Service Update

N232397530 SBZA Modules Installed on Wrong Side of Rear Bumper

Release Date: April 2023

6328031

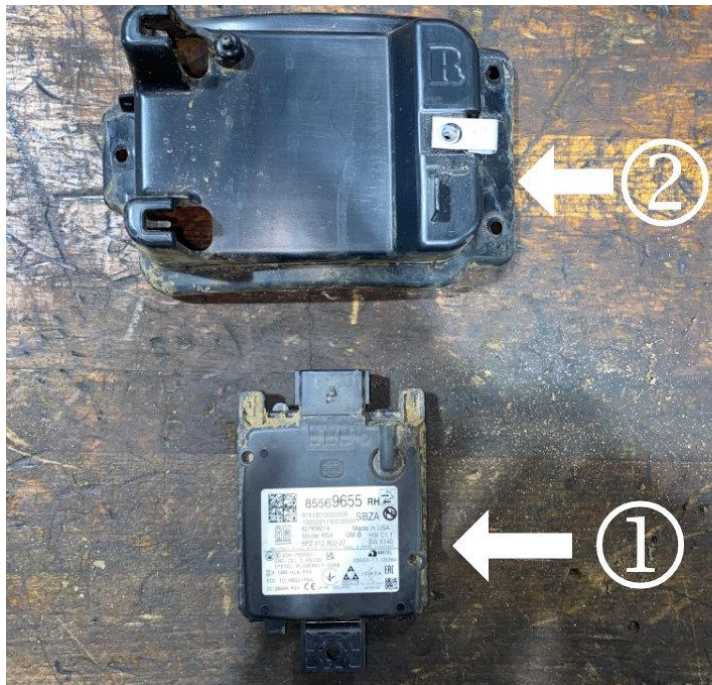
Note: The label on the module has “RH” listed after the part number to indicate it is the RH Side Obstacle Detection Control Module. The bracket has an “R” molded into the part to indicate it is the R bracket.

- Verify the RH Side Obstacle Detection Control Module (1) is installed in the R bracket (2).
- Install the RH Side Obstacle Detection Control Module (1) and R bracket (2) onto the passenger’s side of the vehicle. Refer to *Side Obstacle Detection Control Module Replacement (ULV)* in SI.

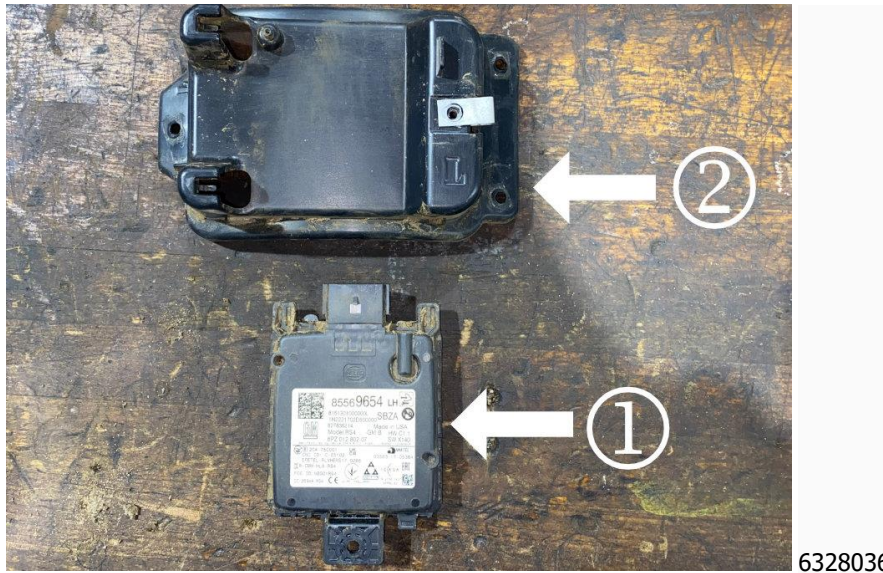
Note: The label on the module has “LH” listed after the part number to indicate it is the LH Side Obstacle Detection Control Module. The bracket has an “L” molded into the part to indicate it is the L bracket.

4. Verify the LH Side Obstacle Detection Control Module (1) is installed in the L bracket (2).
5. Install the LH Side Obstacle Detection Control Module (1) and L bracket (2) onto the driver’s side of the vehicle. Refer to *Side Obstacle Detection Control Module Replacement (ULV)* in SI.
